**ADDENDUM #1  
IFB NUMBER – B16-098 IP  
JULY 29, 2016**

**NAME OF PROJECT:** B16-098 IP COLORADO SPRINGS AIRPORT TERMINAL EAST ROOF REPLACEMENT

# EXG ROOFING DETAIL

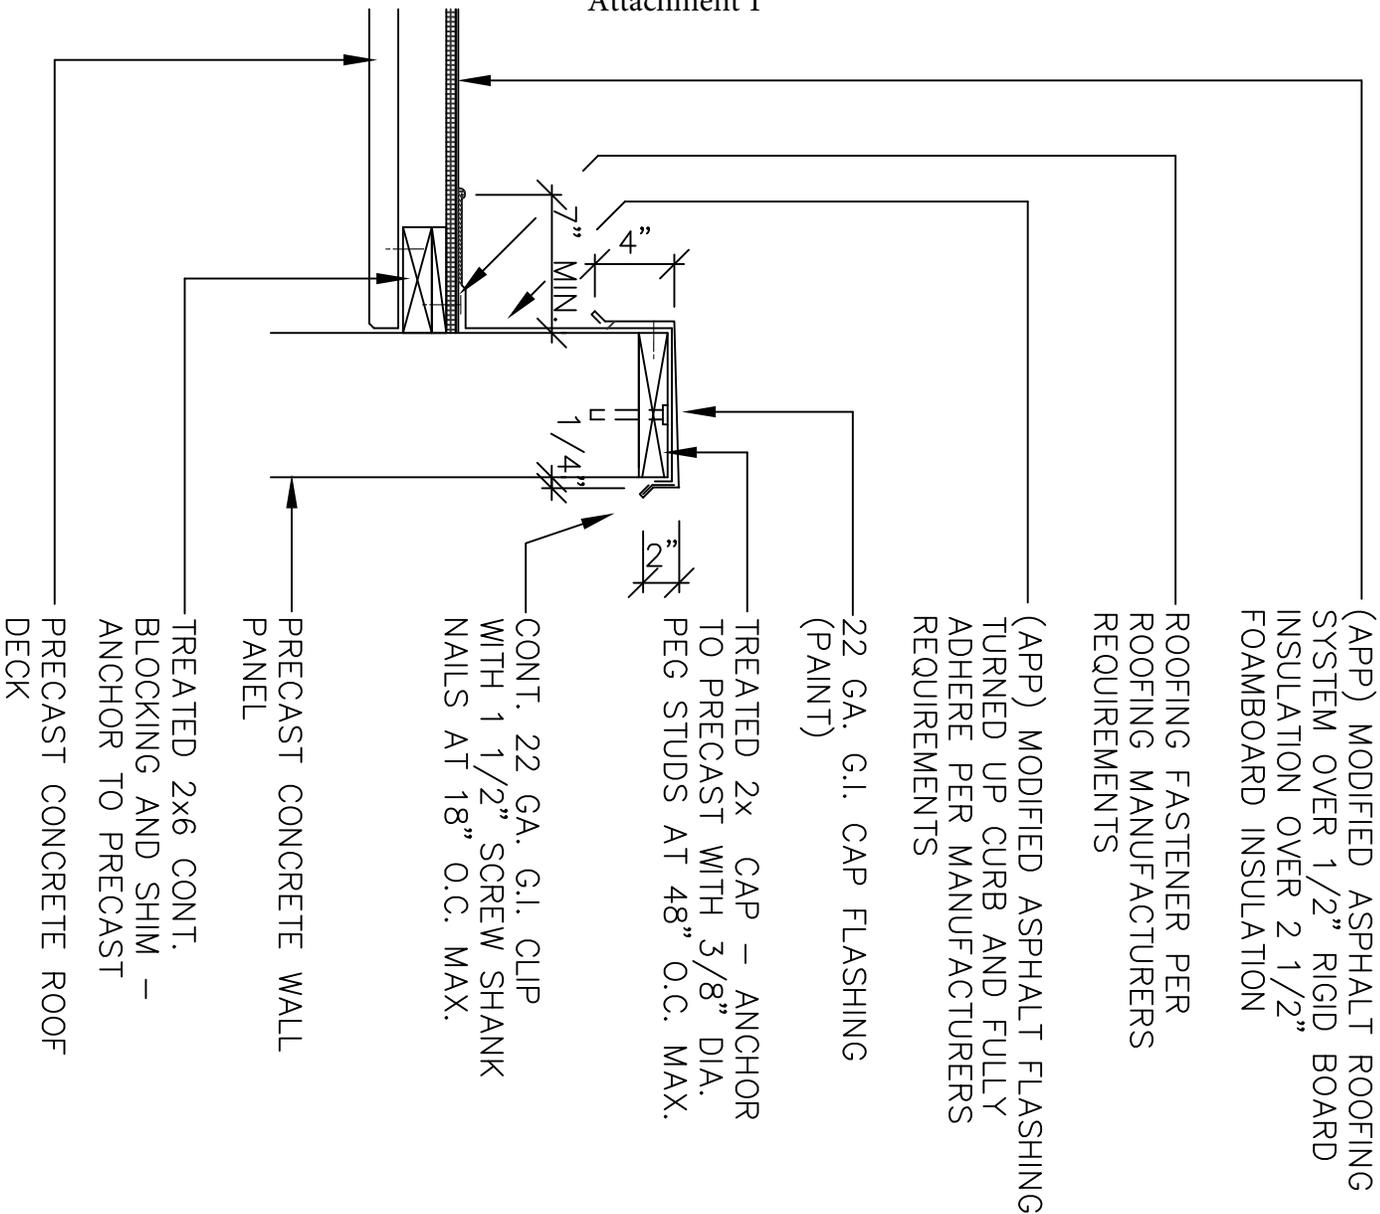
3. **QUESTION:** We were told that there is information in the plans showing the existing roof assemblies. I have not found them, please provide existing roof construction details.

**ANSWER:** This was mistakenly left off. The existing details are provided as Attachment1 to this addendum.
